**OPW** Oifig na  
nOibreacha Poiblí  
Office of Public Works

# Flood Map Update

## MR060 Fermoy

<b>PROJECT</b>	Flood Map Update –MR060 Fermoy
<b>PROJECT NO.</b>	MR060
<b>PROJECT ENGINEER</b>	Kevin Macken / Daniel Walsh
<b>DOCUMENT TITLE</b>	MR060 Fermoy Report

Figure 2-1; Overview of the Map Update Watercourse

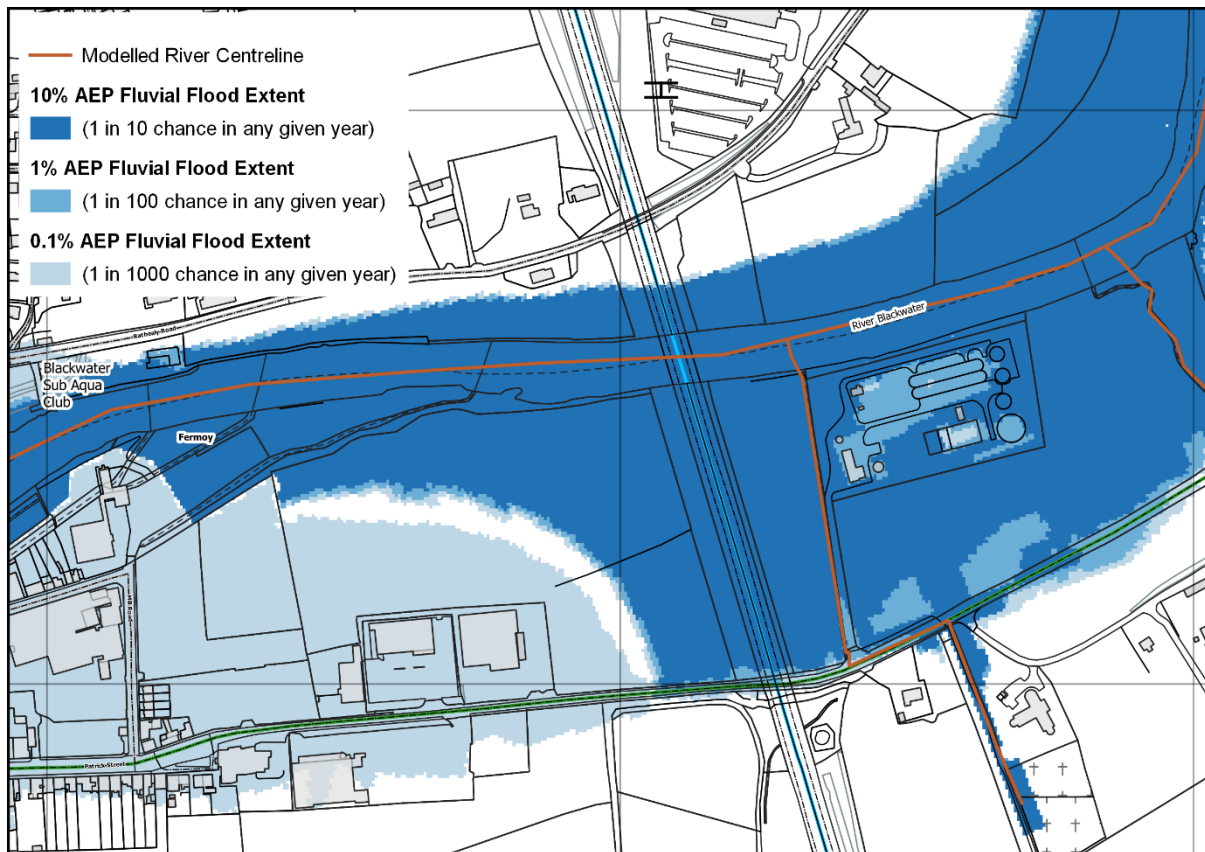
The OPW undertook a review of predicted flooding of motorways and other critical infrastructure. As part of this review, it was found that the M8 Bridge at Fermoy over the River Blackwater was identified as being at risk of flooding, see Figure 2-1. The bridge is significantly elevated over the river valley in this location as can be seen in Figure 2-2. Furthermore, the bridge piers are unlikely to have a substantive effect on the flood flows.

As an error has been identified in the flood mapping for this area a Map Review is justified in this case.

Figure 3-1; TII LiDAR & 0.1% AEP High-End Future Scenario

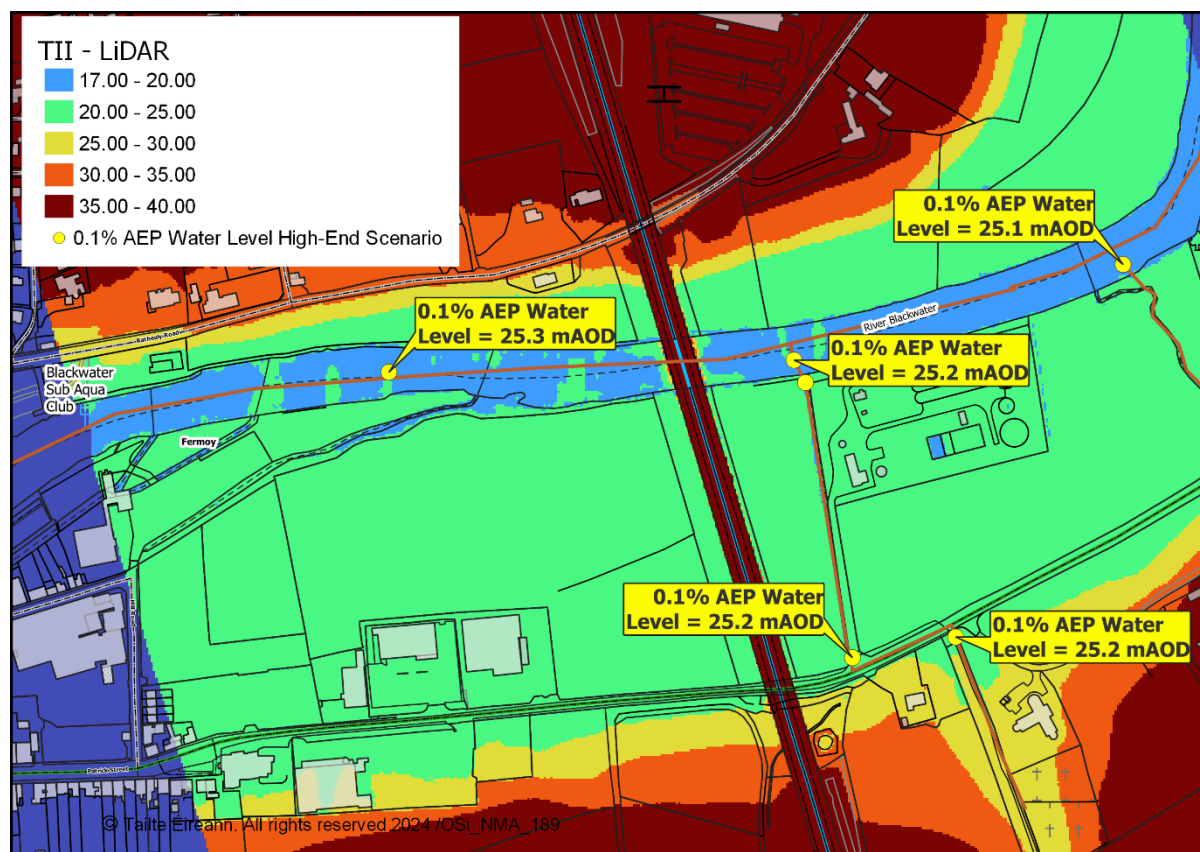
Transport Infrastructure Ireland (TII) has captured LiDAR of the motorway network. This data, illustrated in Figure 3-1, was compared with the 0.1% AEP High-End Future Scenario water levels. This is the most extreme event considered in the OPW's flood datasets. The motorway carriageway is typically 10m above the peak water level of the 0.1% AEP event and as such not at risk in any simulated event.

Figure 3-2; Updated Flood Map

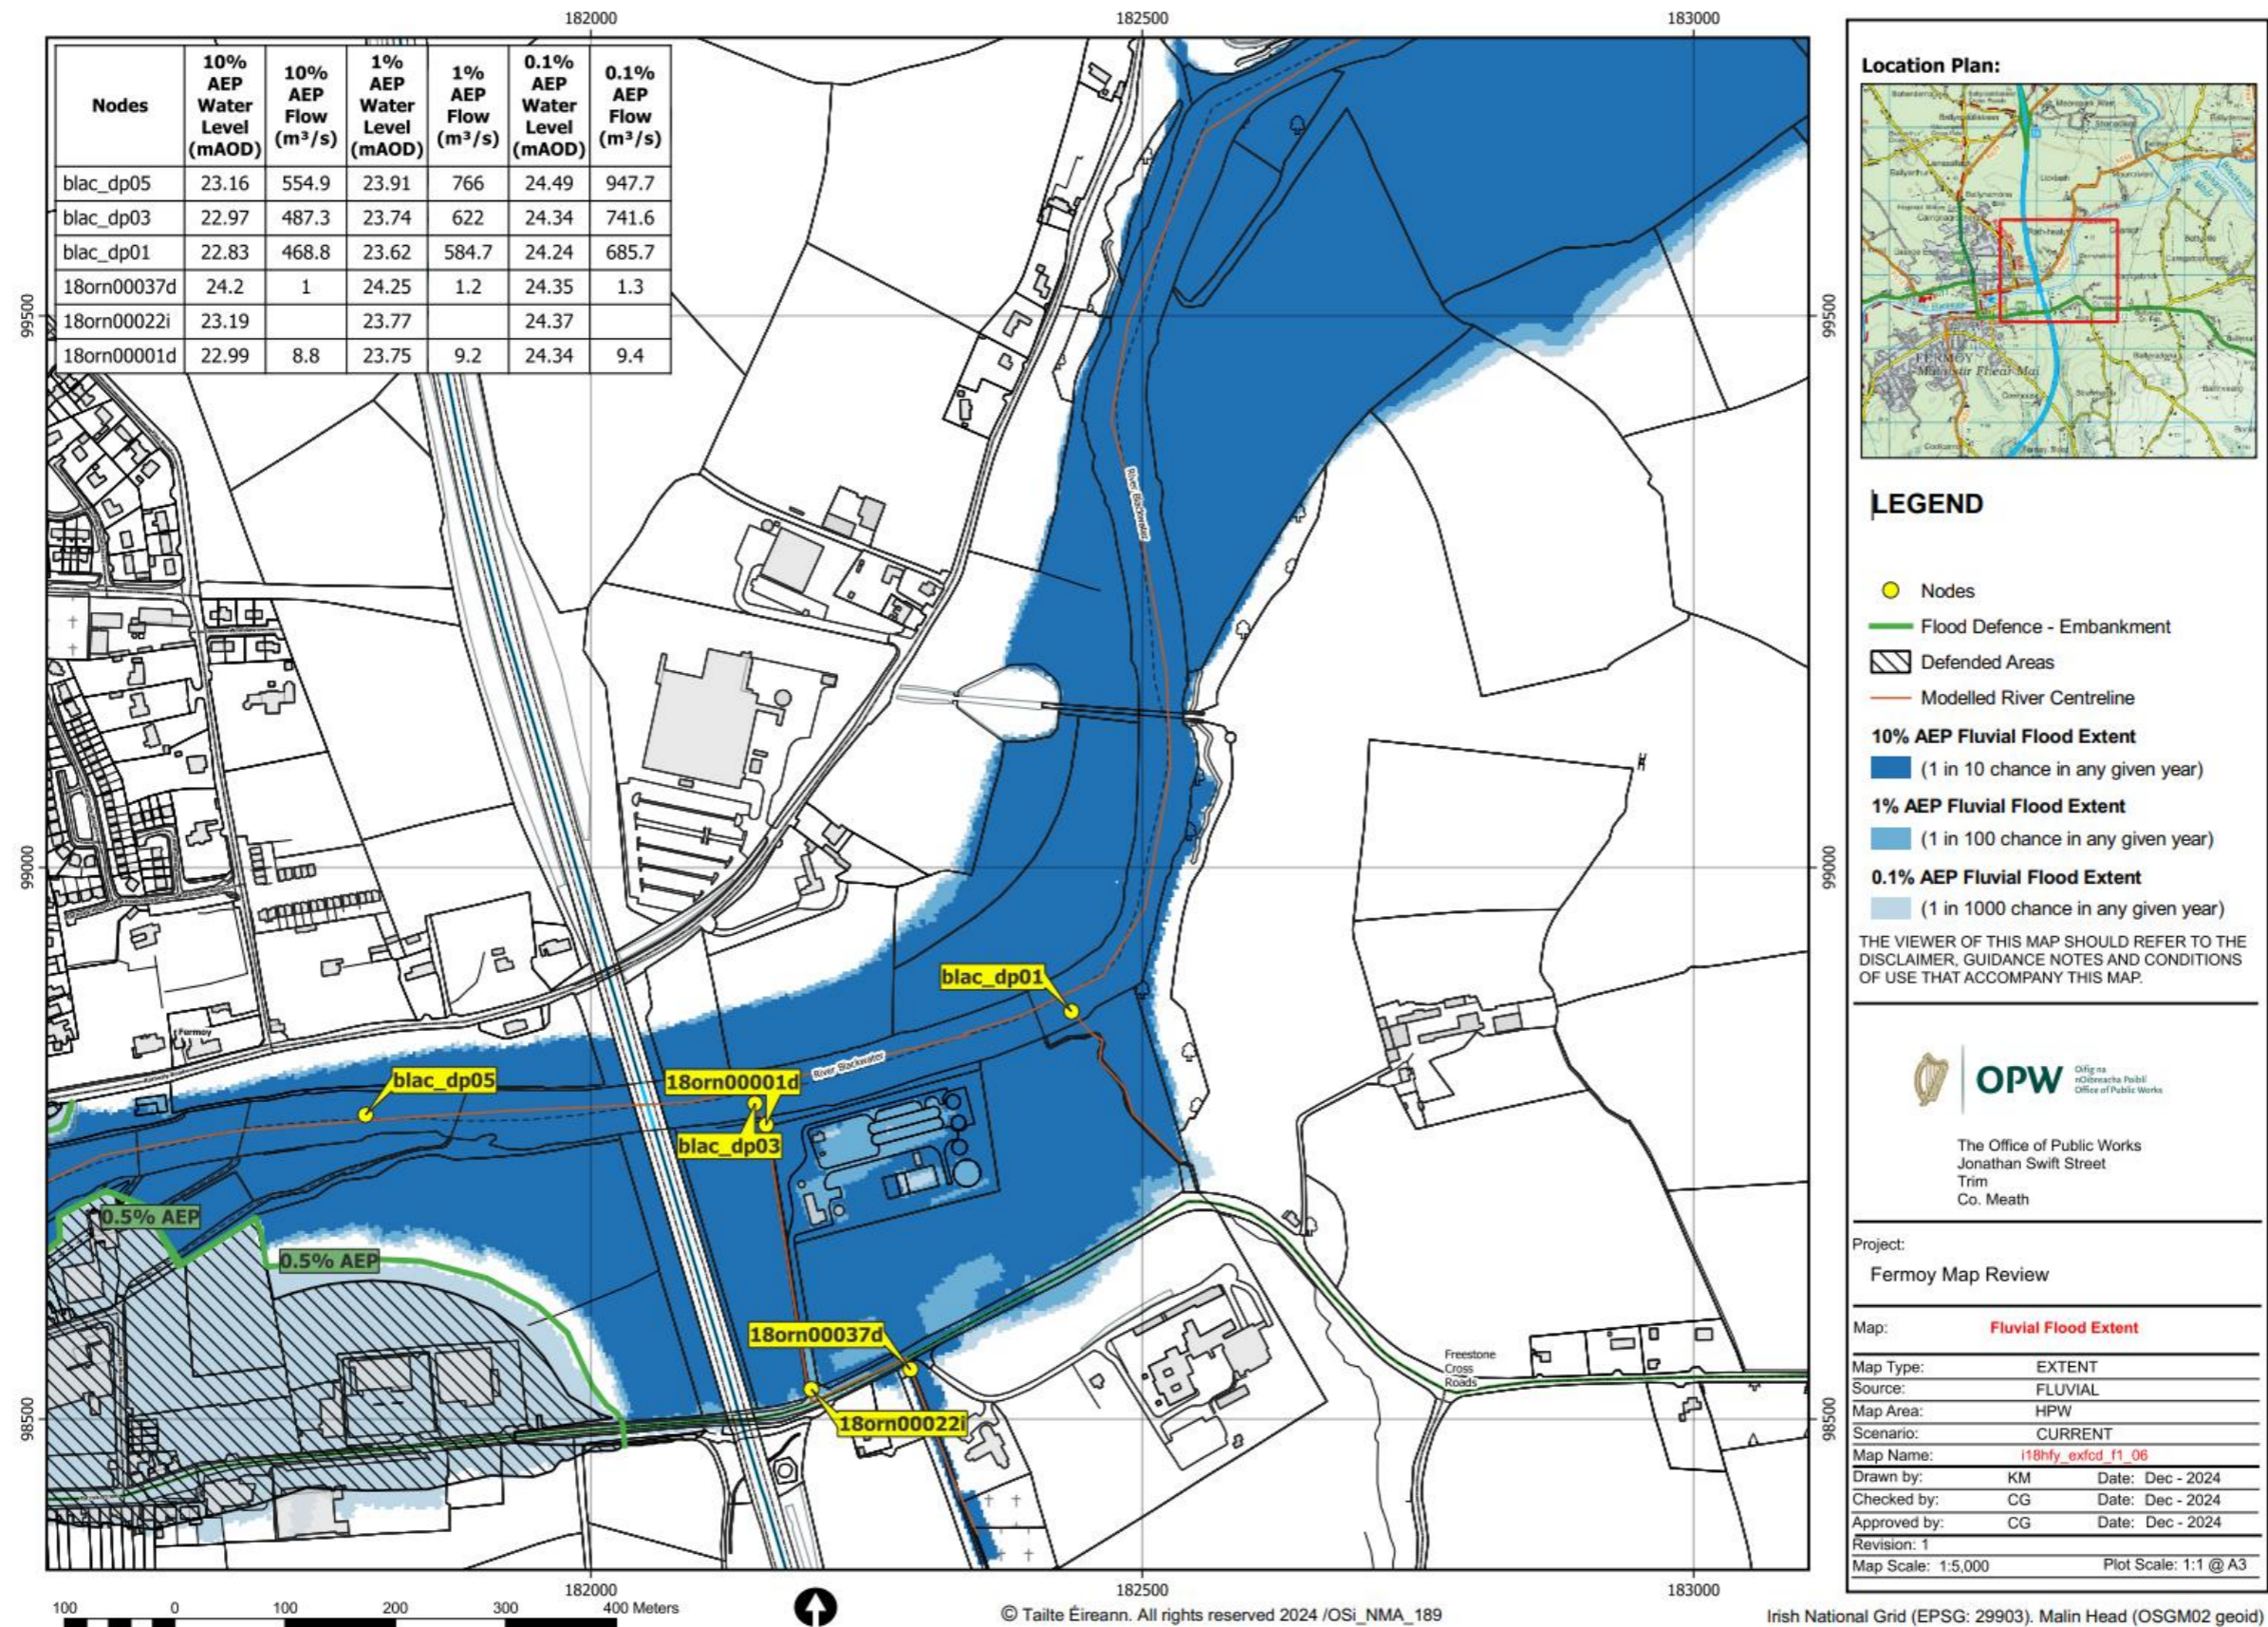
The maps have been updated to reflect the analysis that confirmed the bridge is not at risk in any simulated event. The bridge deck, as defined by the available Prime 2 mapping and TII LiDAR, has been clipped out of all flood mapping datasets. The updated mapping is shown in Figure 3-2.
